Access Compliance Report Public Rights-of-Way (Curb Ramps)

Main Street: WOODLAWN_AVE Cross Street: SIERRA_ALTA_DR Location: SE

ADA ID: RPAT211013085118 Ramp Type: Type 1 - Perpendicular Diagonal Initial Pass/Fail: Pass Overall Compliance: No Severity Score: 2

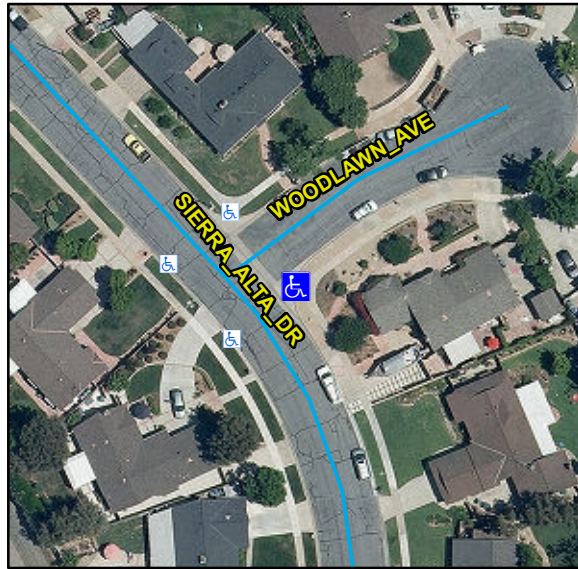
R304.5.3, STD 1115

Remove & Replace Curb Ramp With Two New Directional Ramps or Equivalent.
